Staff Report Addendum

Subject: **8285 Piney River Avenue - Douglas County Libraries - Location and Extent - Supplemental Information**

Project File: **LE2025-025**

Re: ***LE2025-025 – Referral Response Memo***
Project #: 1296.0001.00

STERLING RANCH FILING 1, LOT X
DOUGLAS COUNTY LIBRARIES (L&E)

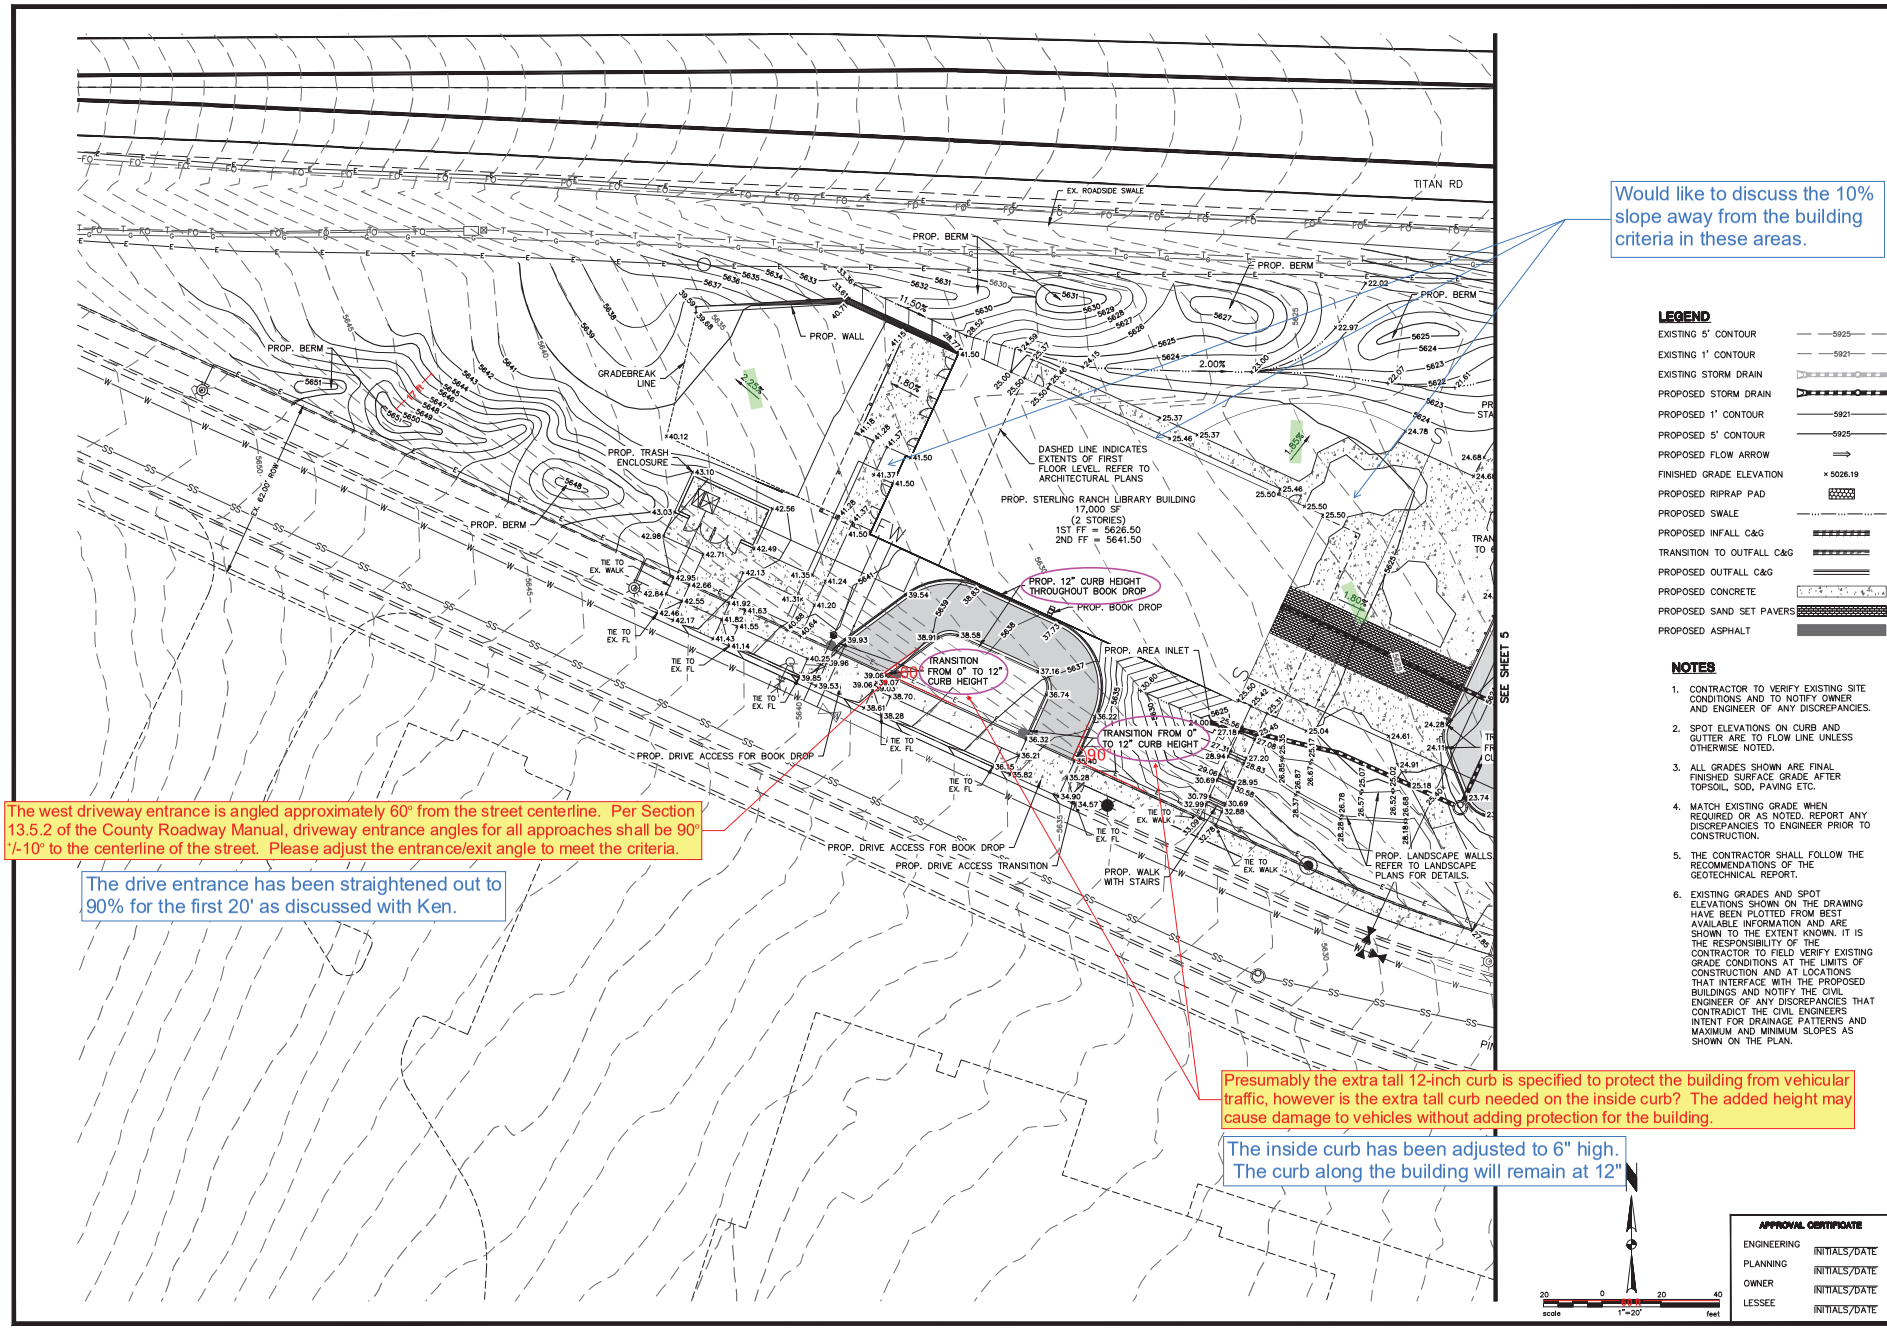
The construction notes are probably not needed on the L&E exhibit. Consult with the County planner regarding this.

This sheet has been removed from the L&E plans.

LANDSCAPE SITE PLAN (WEST)

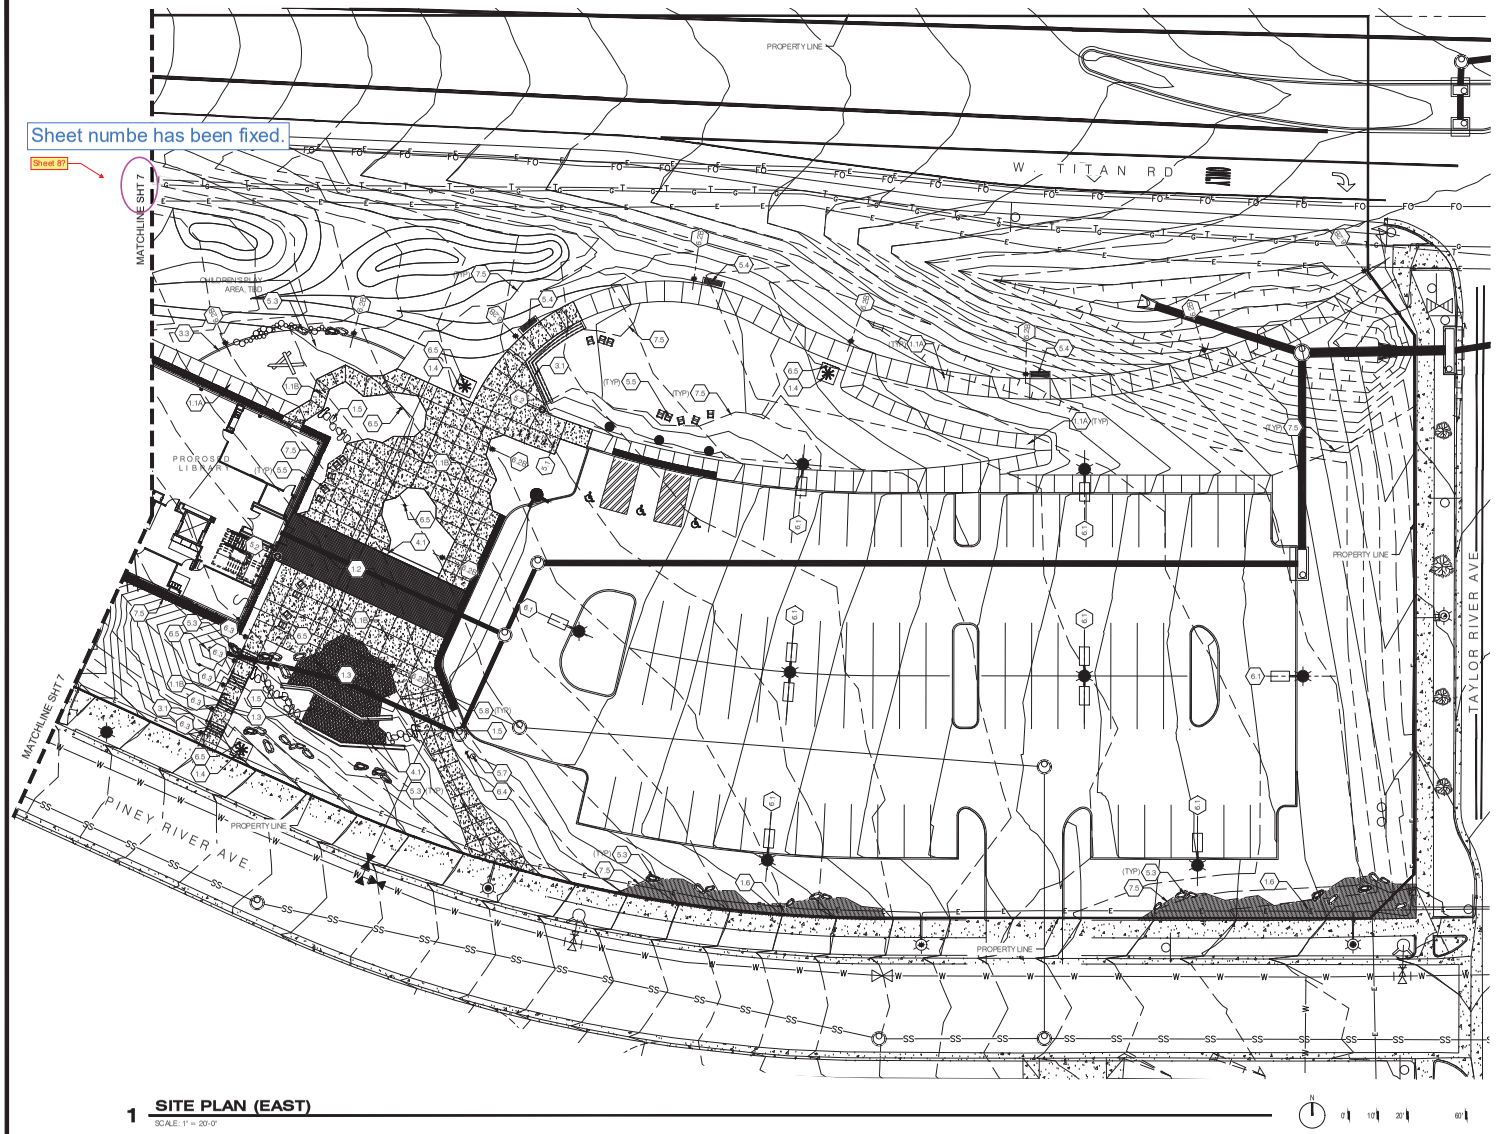
It appears a part of the site is missing between the matchlines shown on Sheets 8 and 9.

Check matchline locations and revise as needed.

Matchlines have been corrected.

Sheet numbe has been fixed.

LANDSCAPE SITE PLAN (EAST)

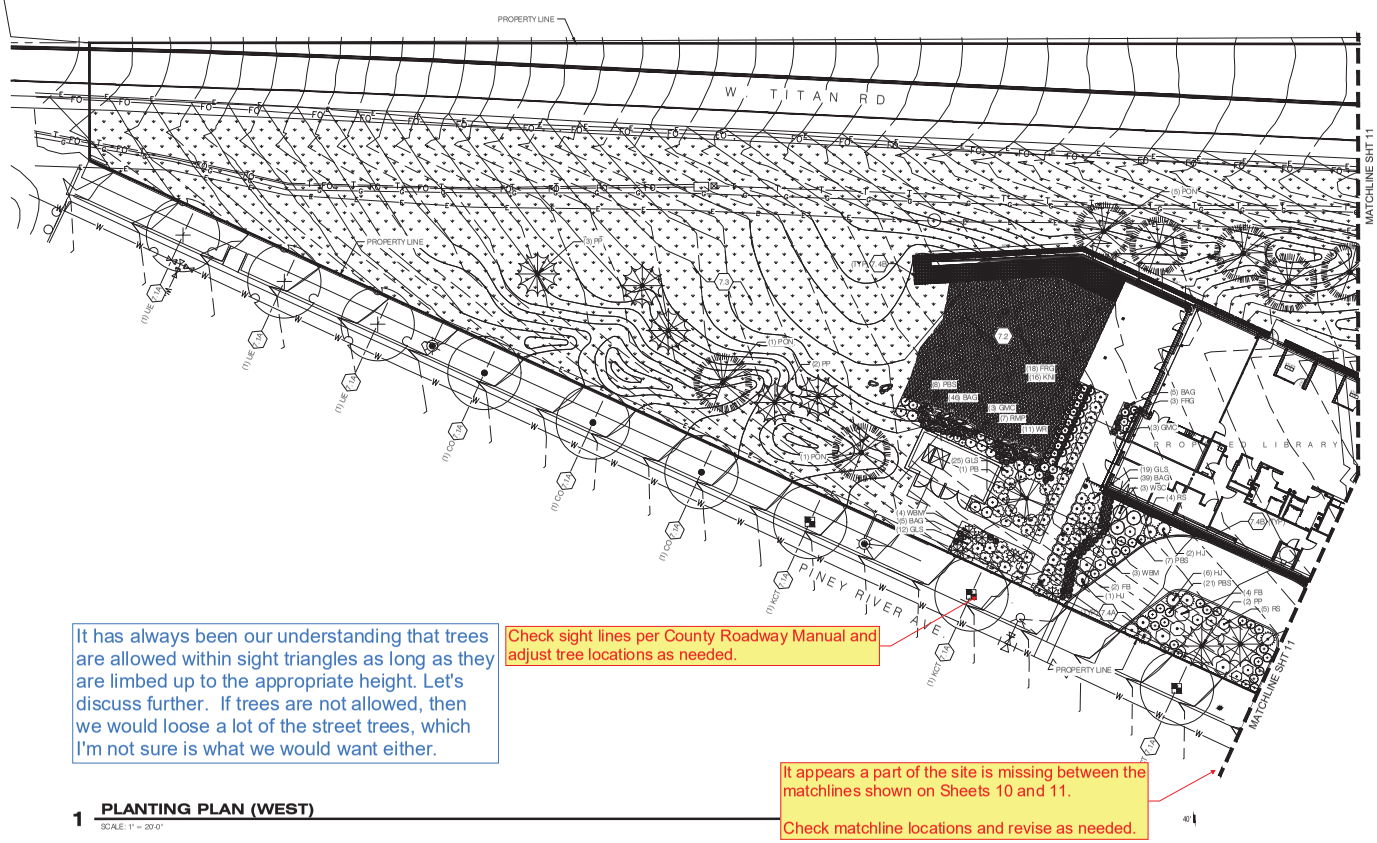
Check sight lines per County Roadway Manual and adjust tree locations as needed.

It has always been our understanding that trees are allowed within sight triangles as long as they are limbed up to the appropriate height. Let's discuss further. If trees are not allowed, then we would loose a lot of the street trees, which I'm not sure is what we would want either.

PLANTING PLAN (WEST)

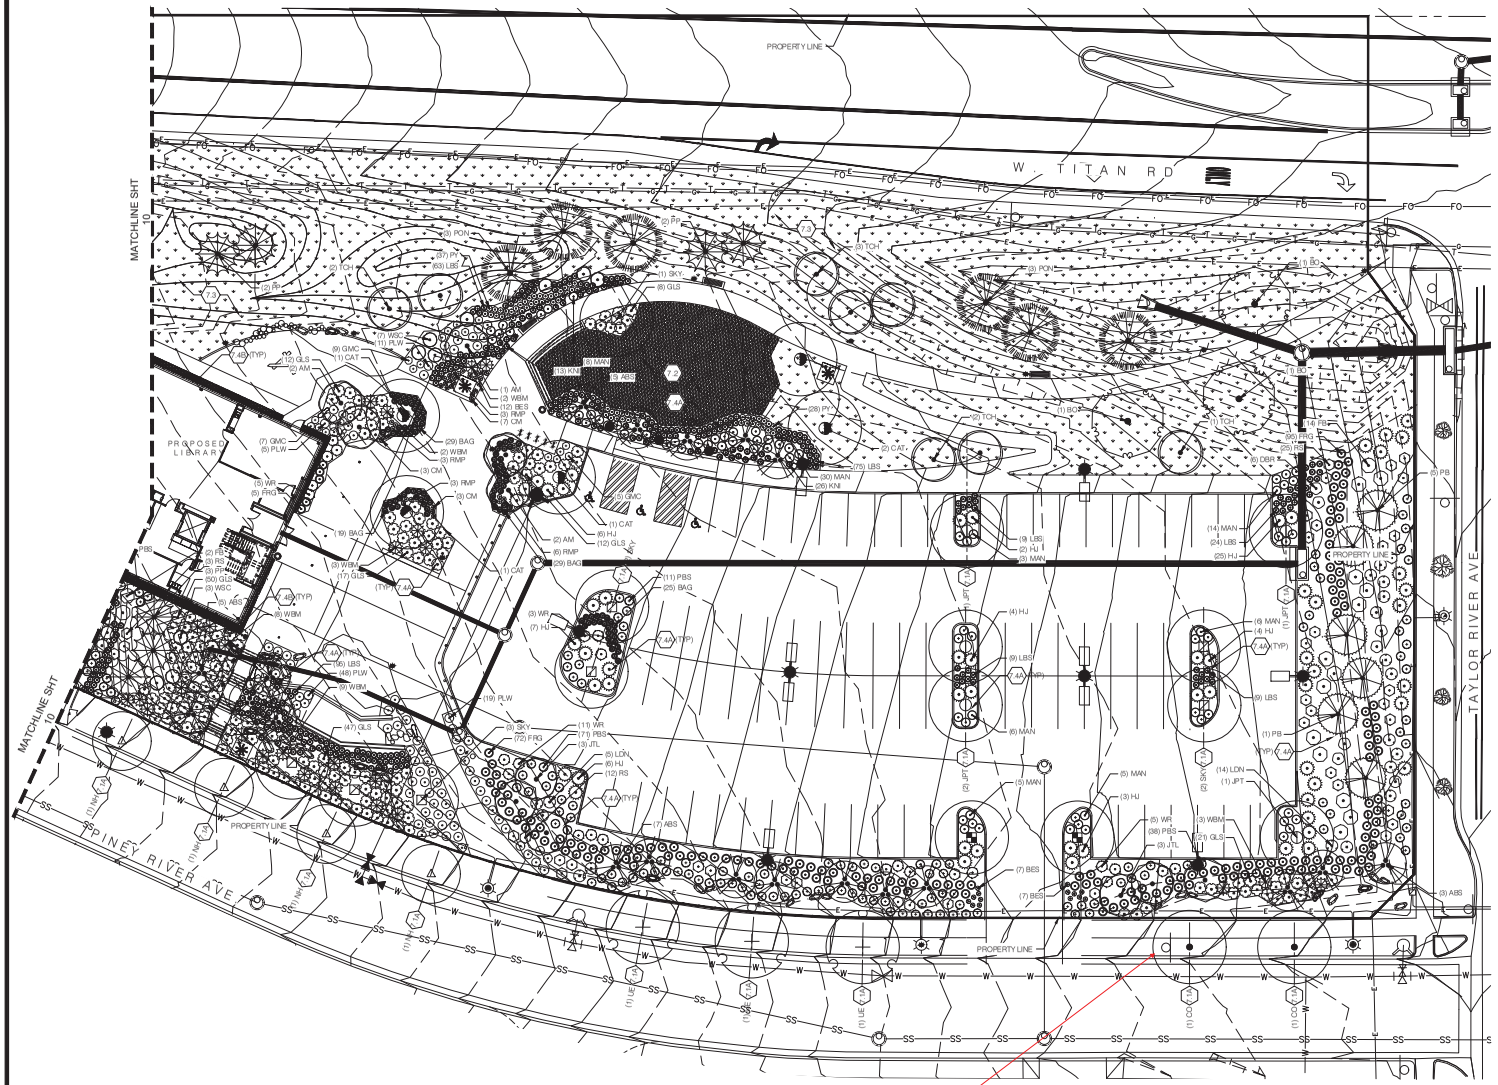
It appears a part of the site is missing between the matchlines shown on Sheets 10 and 11.

Check matchline locations and revise as needed.

Matchlines have been corrected.
